NUCLEAR REGULATORY COMMISSION STAFF
SAFETY EVALUATION
OF
U. S. DEPARTMENT OF ENERGY
QUALITY ASSURANCE PROGRAM DESCRIPTION
FOR THE
OFFICE OF CIVILIAN RADIOACTIVE
WASTE MANAGEMENT

MAY, 1989

SAFETY EVALUATION

FIGURE 1
OFFICE OF CIVILIAN RADIOACTIVE WASTE MANAGEMENT
ORGANIZATION

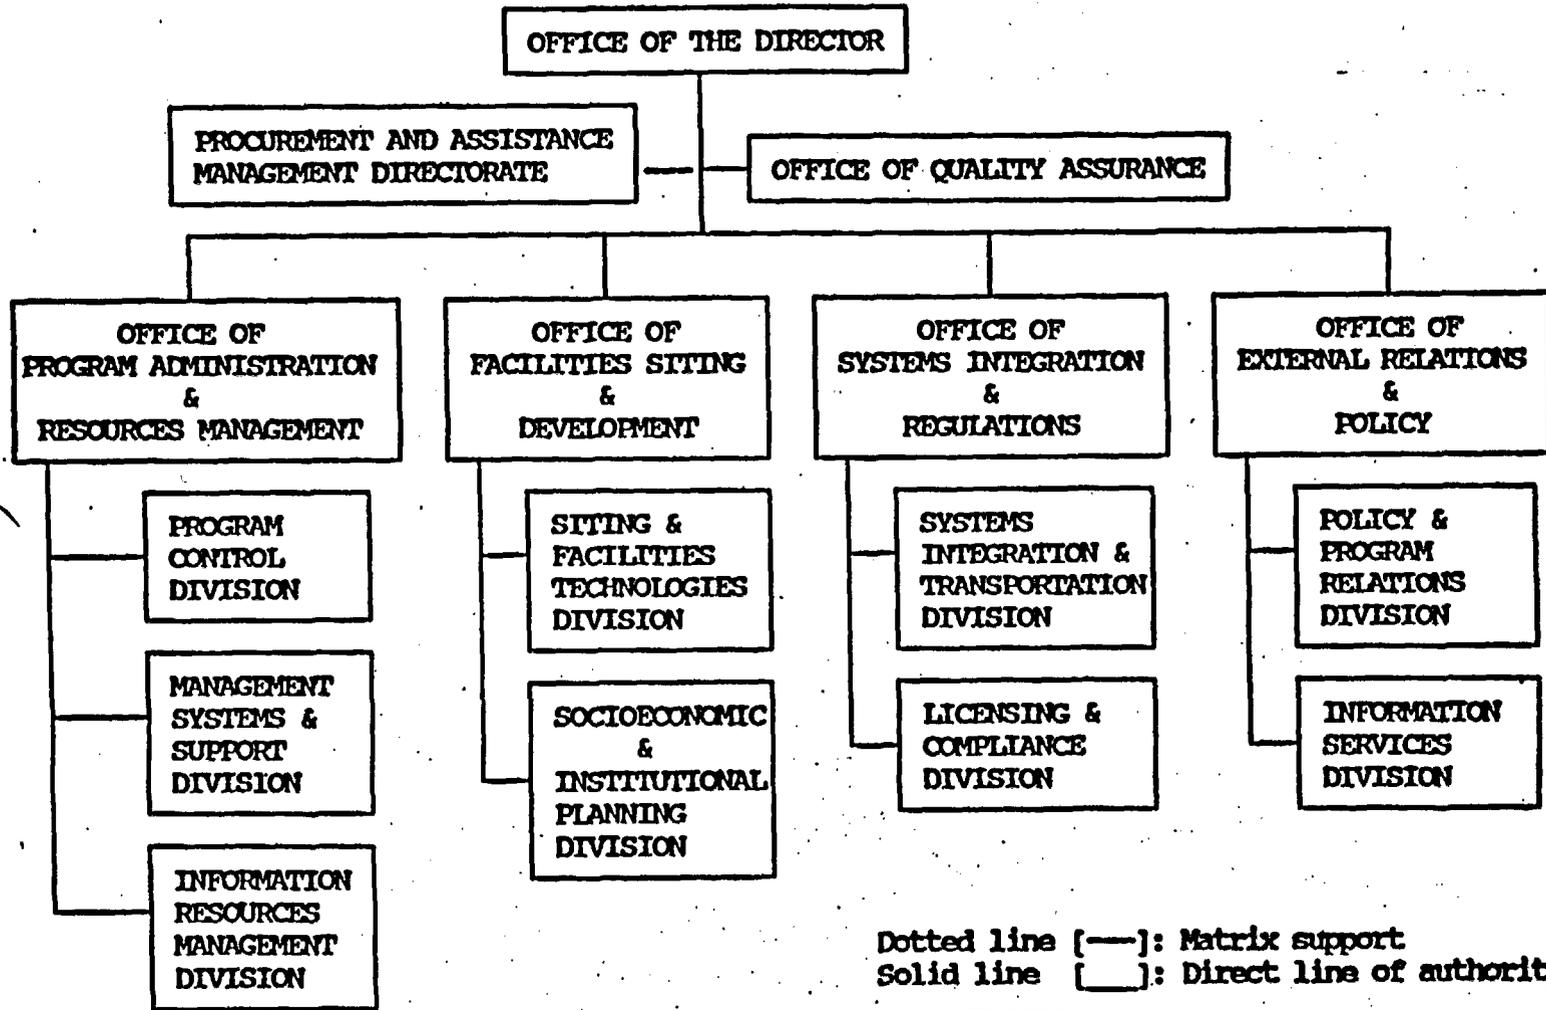
Figure 1 shows the organization of the OCRWM for QA. This includes the Office of the Director and the Offices of: Quality Assurance; Program Administration and Resources Management; Facilities Siting and Development; Systems Integration and Regulations; and External Relations and Policy. The Director, OCRWM reports directly to the Office of the Secretary, U. S. Department of Energy and has overall responsibility for the high-level waste repository program. The QA responsibilities of the Director, OCRWM include: (1) establishing and executing a QA program to assure compliance with applicable regulatory and licensing requirements; (2) establishing QA policy

The NRC staff recommends that DOE incorporate the above guidance into the QAPD to better define the responsibilities of the QA and and line organizations. This is identified as an open item in Section 5 of this evaluation. With the inclusion of the above into the QAPD, the QAPD meets the ANSI/ASME NQA-1-1986 (see Ref. 7) criteria for QA organization responsibilities and is acceptable to the NRC staff. However, for the implementation of the QAR and the QAPD, the NRC staff believes that DOE should continue to have the additional QA involvement currently prescribed in the YMP 88-9 QA Plan (see Ref. 1) and the QAPD, since the program has not yet been shown to be effective. When DOE wishes to have less QA involvement, it should meet with the NRC staff and discuss which QA functions will be transferred to the line organization and how the independence will be maintained to assure that the line organization is effectively performing its respective QA/quality control functions and is in compliance with the requirements for organizational responsibilities, including paragraph 2 of NQA-1 (see above).

In Section 3.1 of this SE, a discussion is provided pertaining to guidance on the role of the QA organization. DOE should incorporate the guidance from paragraph 2 of ANSI/ASME NQA-1-1986 Nonmandatory Appendix 1A-1 into the next revision of the QAPD.
